Project	Baptist Church, Rochdale Road, Manchester
Report Title	Stage 2 Fire Engineering Review
Our Ref	JM2706/R1 Issue 1

Baptist Church, Rochdale Road, Manchester

Stage 2 Fire Engineering Review

JM2706/R1

Figure 3: Indicative Flat Layout – 2 Bed Flat

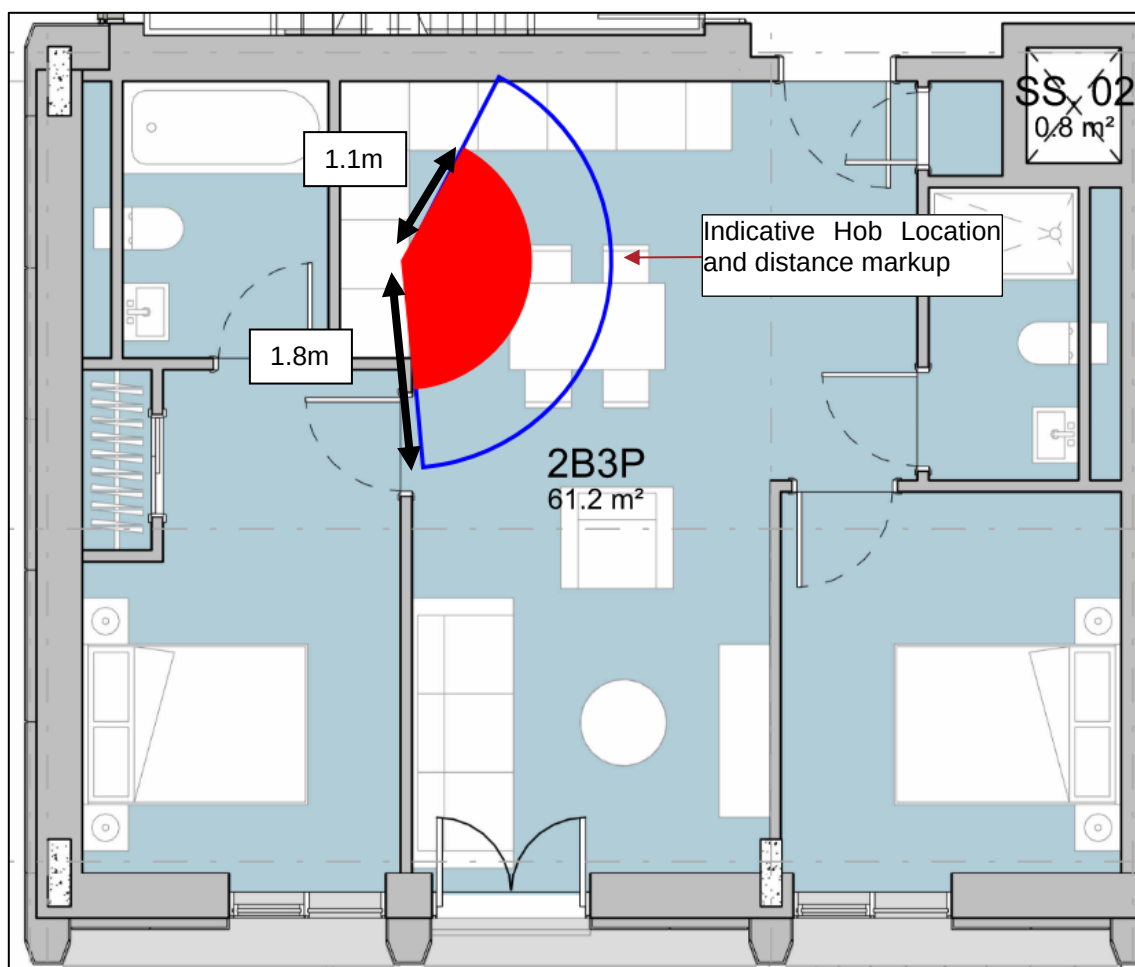
Draft BS9991 guidance recommends that any open plan flats that have a dimension of 8m x 4m will need to enclose the kitchen. JH can develop a technical argument to omit this from the scheme however for this strategy to work, the cooking appliances should be located at least 1.8m from an opposing wall or door. Current guidance does not specify a distance from where hob distances are suitable and only requires hob distances to be located away from escape routes and final exits. In the proposed drawings, this 1.8m would likely be easily achieved.

However currently the draft BS9991 guidance recommends distances of at least 2.7m from an opposing wall / final exit which is likely not achieved in the current layout depending on the proposed hob location. JH would recommend where possible, this is achieved and any shortfalls in this 2.7m distance can be addressed with a fire engineered approach as discussed above.

Figure 5: Stair Door Swing

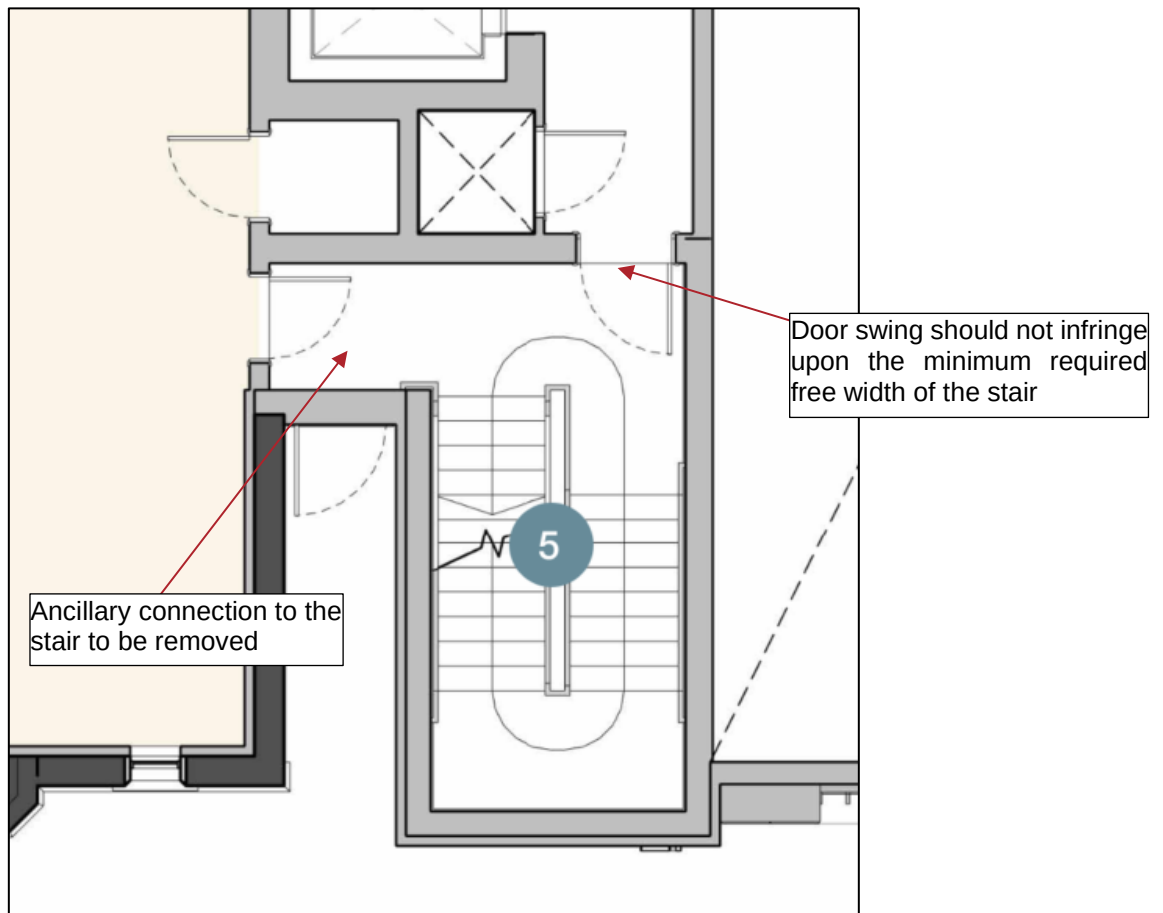
The storey exit doors should be designed so that the door swing does not infringe upon the minimum clear width required for the stair. This is not achieved in current plans. Therefore, either the door should be set back so that the door does not infringe upon the stair or the storey exit doors could open into the corridor rather than into the stair.

The latter approach would mean that the occupancy at each floor would be limited to 60 occupants. This would not include the ancillary areas on the lower ground floors unless the stair connection is removed as outlined above in Section 6.2.3. With the ~14 occupants from the flats, the upper level occupancy being limited to 60 will be fine.

With the ancillary spaces doors are removed, this would limit the total ancillary areas maximum occupancy to 46 at each level. This should be confirmed an acceptable maximum occupancy as part of this approach.

Figure 6: Extended Plant Room Travel Distances at Mezzanine Plant Level

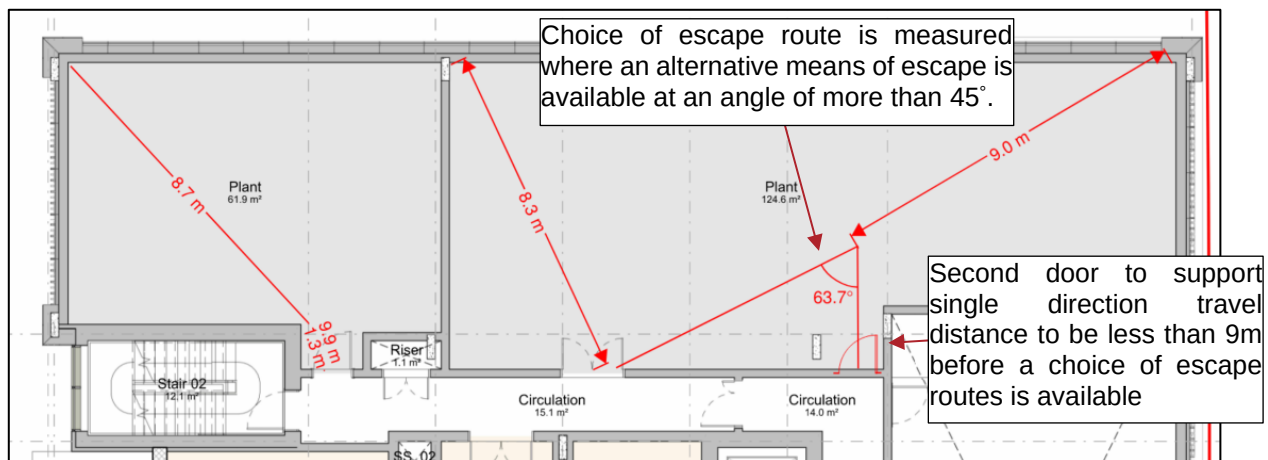
Plant rooms should be limited to 9m in a single direction and 18m for escape in more than one direction. This is not achieved in current plans, with extended travel distances as shown in Figure 6. JH would recommend that a second door is added to the large plant room. Given the increase in travel distances is minor at ~0.9m, JH can support the arrangement as marked up below as a fire engineered which would need agreement with the BSR.

Figure 7: Ground Floor Commercial Unit

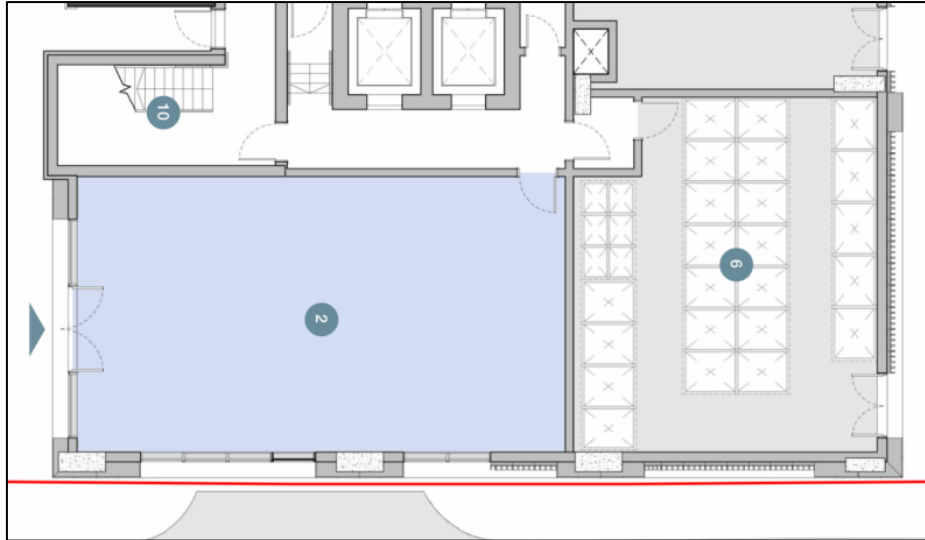
Currently there is an exit shown into the rest of the building. The commercial unit should be constructed as a separate fire compartment and should share no means of escape as existing, therefore the rear door opening into the ground floor corridor should be removed.

Figure 8: Typical Upper Level Smoke Ventilation Layout

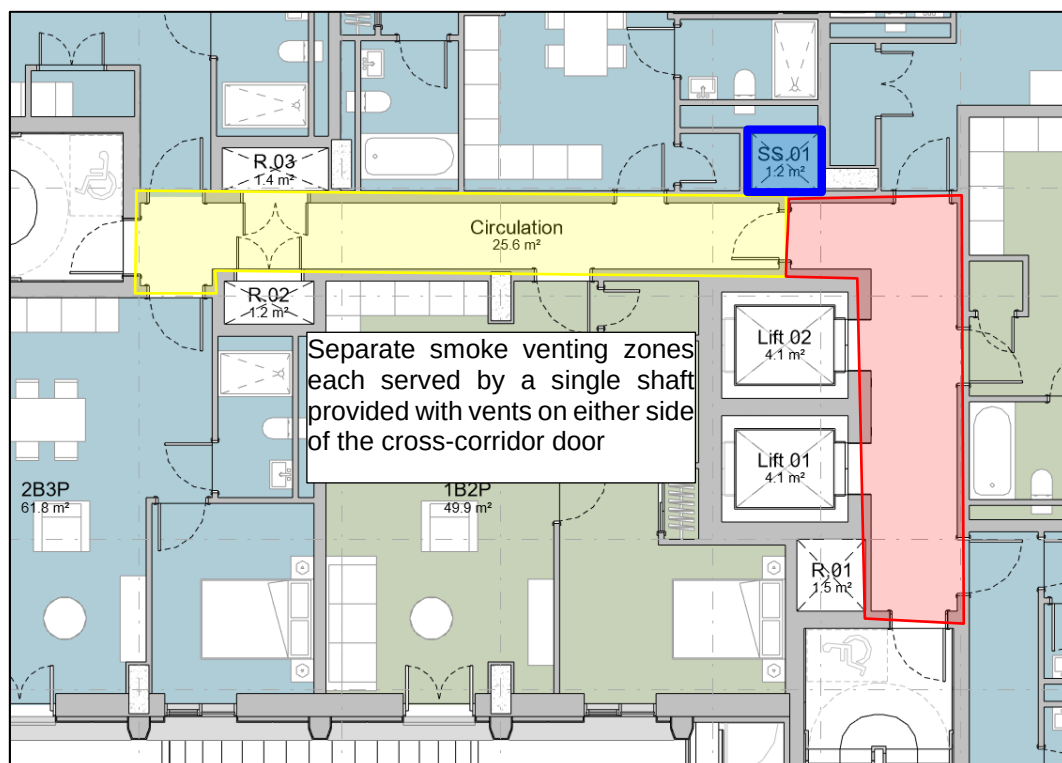
Residential common corridors should be provided with a smoke control system in line with Section 8.1 above to protect each stair. For code compliance, the smoke extract shafts should be sited as far as possible away from the stair. It is understood that the current smoke venting proposal will have a single mechanical smoke shaft located next to the cross corridor door and provide with a fire and smoke damper so that the single smoke shaft can serve either section of the corridor separately.

The size of the smoke shaft should be confirmed by the smoke venting specialist.

Figure 10: Proposed Door Arrangement

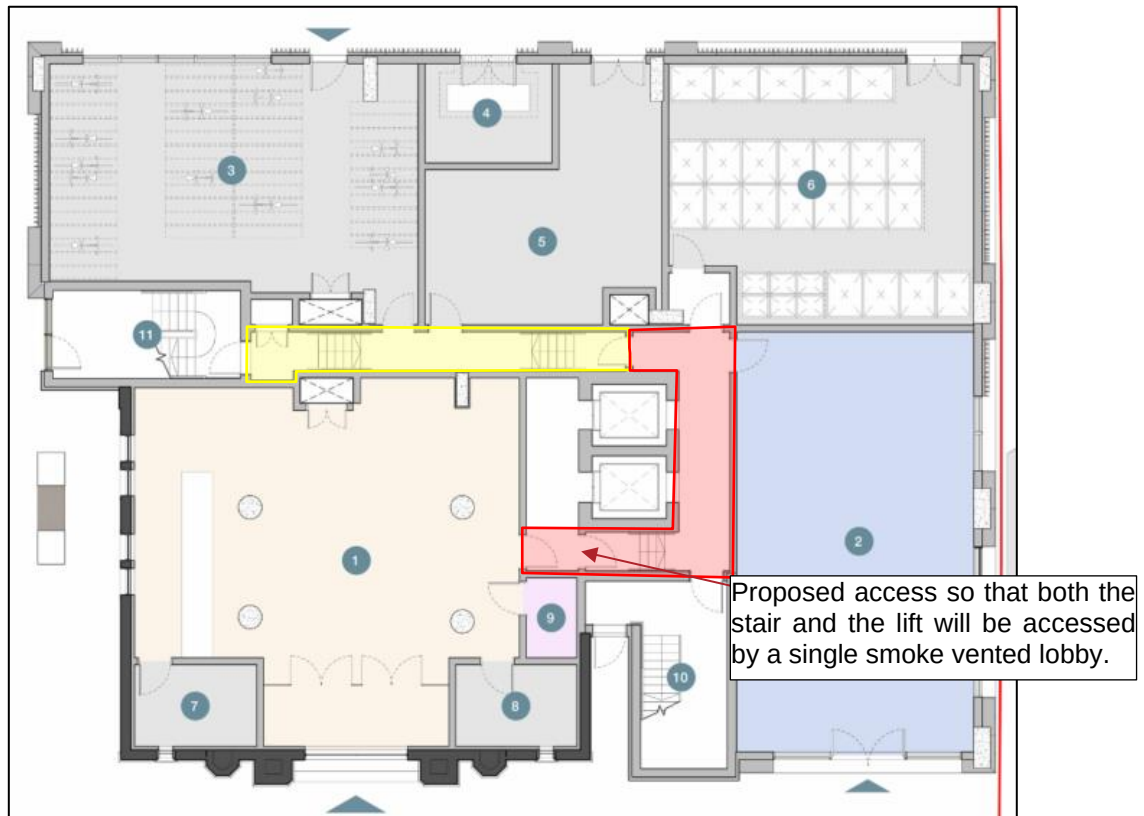
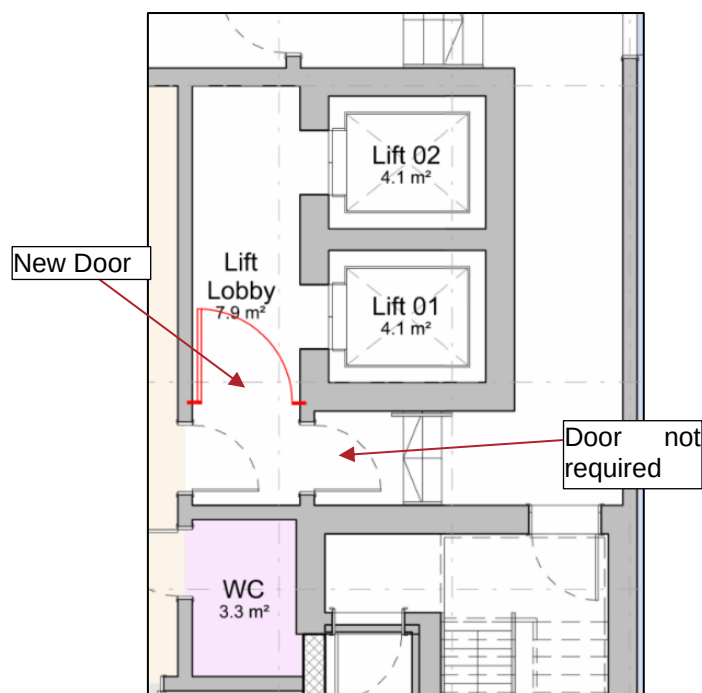
At ground floor, each stair as well as the lift lobby should be smoke vented. To omit the need for a separate third smoke vent to serve the lift lobby from the ground floor foyer, the doors should be rearranged as shown in Figure 10 below.

Figure 11: Fire Protection of residential corridors from void space (Typical for level with void space)

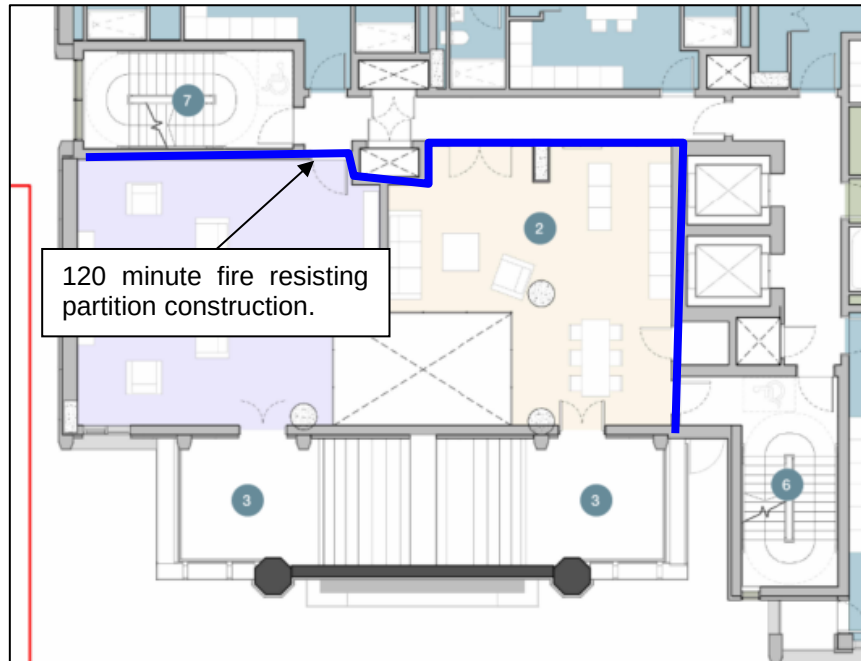
Floors throughout the building should be constructed as a compartment floor at each level (as discussed in Section 9.2). However it is proposed that the ancillary areas are designed a separate 120 minute fire compartment. As a separate compartment which could be treated as a separate building, there would be no requirement for compartment floors for the ancillary spaces. As a result, if there are no compartment floors within the ancillary space, the compartment would not be considered as an atrium from a fire strategy perspective and therefore no additional requirements such as atrium smoke venting or fire resisting glazing.

Figure 13: Residential Level External Elevations

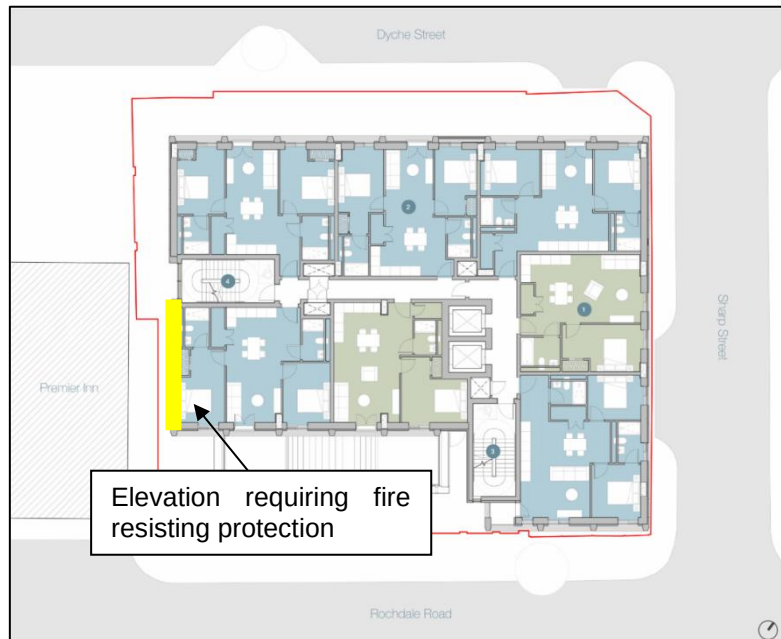
The results show that there should be no restrictions to any of the elevations that are facing the roads except to elevations facing Southwest due to the close site boundary. This is shown in Figure 13.

Figure 14: External Wall Fire Protection – Mezzanine

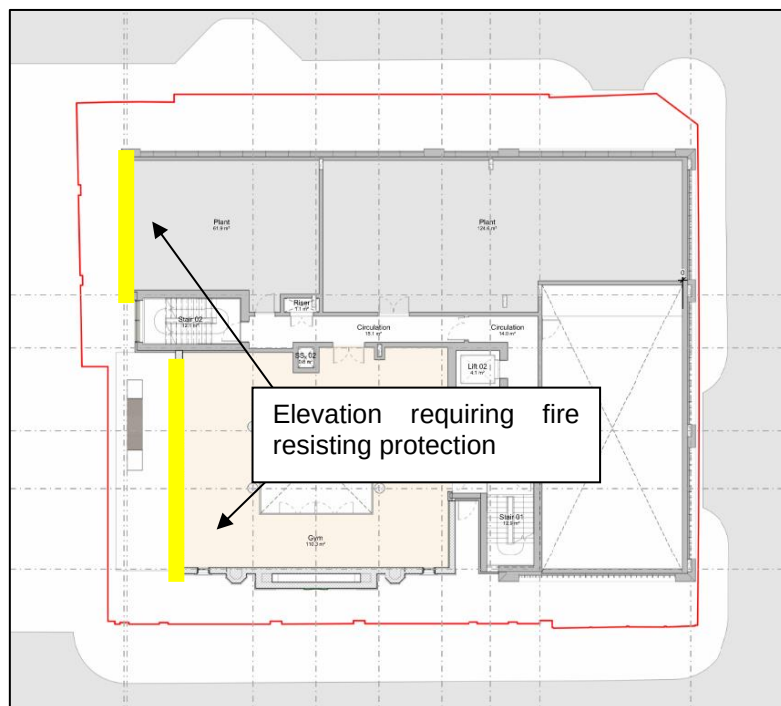
Elevations of plant, ancillary spaces (entrance foyer, gym etc) and the southernmost residential flat facing neighbouring buildings would not achieve an 100% unprotected area and therefore should also be provided with fire resisting protection as shown in Figure 14. Detailed calculations calculating the exact unprotected areas allowed on these elevations will be provided in the Fire Strategy report as the scheme progresses.
